# UNITED STATES PATENT AND TRADEMARK OFFICE

APPLICATION NO.	FILING DATE	FIRST NAMED INVENTOR	ATTORNEY DOCKET NO.	CONFIRMATION NO.
10/538,248	06/09/2005	Steven L Williamson	10555-103	3294

<b>Office Action Summary</b>	Application No. 10/538,248	Applicant(s) WILLIAMSON, STEVEN L	
	Examiner Jennifer Doan	Art Unit 2874

**FIG. 2**

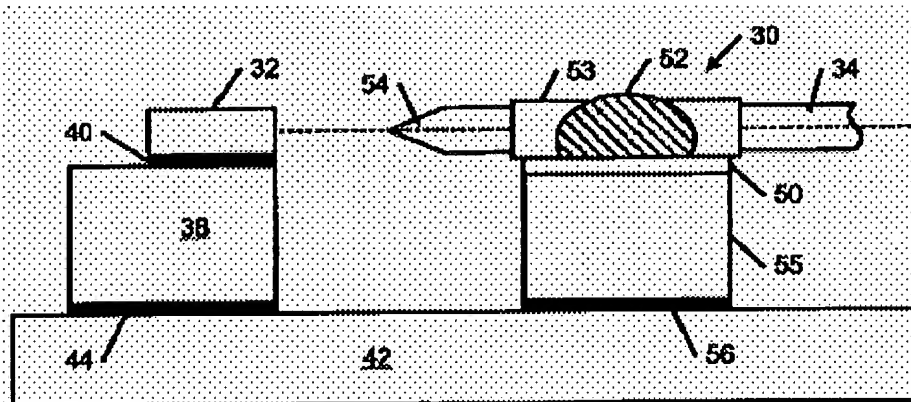
With respect to claim 16, Ziari et al. (figure 2) disclose an optical fiber attachment comprising a hot pad (50); solder glass (52) positioned on the pad (50), the solder glass (52) attaching the fiber (34) to the hot pad (50).

With respect to claim 17, Ziari et al. (figure 2) disclose the optical fiber, wherein the hot pad (50) includes a substrate (55).

With respect to claim 19, Ziari et al. (figure 2) disclose the optical fiber, wherein heat is removed from one side of the substrate (55) to concentrate heat to the opposite side of the substrate (55), the solder glass (52) being positioned on the opposite side (see paragraph [0032]).

With respect to claim 21, Ziari et al. (figure 2) disclose the optical fiber, wherein the one side straddles a slot in a module floor to which the hot pad (50) is mounted (see figure 2).
